Access Compliance Report Public Rights-of-Way (Curb Ramps)

Intersection ID: 48417 Main Street: WINDS CROSSING DR **Cross Street: CAROWINDS BV** Location: NW ADA ID: E2757379FC80 Ramp Type: PerpDiag Initial Pass/Fail: Fail **Overall Compliance: No** Severity Score: 46.25

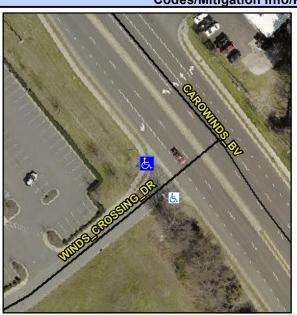
Possible Solutions: Remove & Replace Curb Ramp With Two New Directional Ramps or Equivalent. Surveyor Notes: N/A PROW/ADA: Not Found, R304.5.1, R304.2.2, R304.5.3

Field Measurements/Component Compliance					
Compliance Description		Data	Comp	liance Description	Data
N/A	Ramp Length (in)	48.0	No	Ramp Slope (%)	9.5
No	Ramp Width (in)	47.0	No	Ramp XSlope (%)	8.7
N/A	Flare Type LT	N/A	N/A	Flare Type RT	N/A
N/A	Flare Slope LT (%)	N/A	N/A	Flare Slope RT (%)	N/A
N/A	Flare Traversable LT?	N/A	N/A	Flare Traversable RT?	N/A
N/A	Landing Length (in)	N/A	N/A	DWS Provided?	N/A
N/A	Landing Width (in)	N/A	N/A	DWS Contrast?	N/A
N/A	Landing Slope (%)	N/A	N/A	DWS Length (in)	N/A
N/A	Landing X Slope (%)	N/A	N/A	DWS Full Width?	N/A
N/A	Landing Curb? (Y/N)	N/A	N/A	DWS Offset (in)	N/A
N/A	Shared Landing?	N/A			
N/A	Gutter Ponding?	N/A	N/A	Gutter Slope (%)	N/A
N/A	Gutter Lip Ht (in)	N/A	N/A	Gutter X Slope (%)	N/A
N/A	Painted X Walk1?	No	N/A	Painted X Walk2?	No
	X Walk 1 Direction	To S		X Walk 2 Direction	To E
N/A	X Walk 1 Width (in)	N/A	N/A	X Walk 2 Width (in)	N/A
	X Walk 1 Slope (%)	0.3		X Walk 2 Slope (%)	3.1

X Walk 1 X Slope (%)	4.7		X Walk 2 X Slope (%)	1.9
N/A	Ramp inside XWalk1?	N/A	N/A	Ramp inside XWalk2?	N/A
	Road Slope (%)	5.4	N/A	Clear Space?	N/A
	Road X Slope (%)	6.2	N/A	Clear Space to XWalk (in)	N/A
N/A	Any Obstructions?	N/A	N/A	Storm Grate/Utility Hazard?	N/A
	Obstruction Type			Storm Grate/Utility Type	
		N/A			N/A
			Yes	Surface Condition? (G/P)	Good
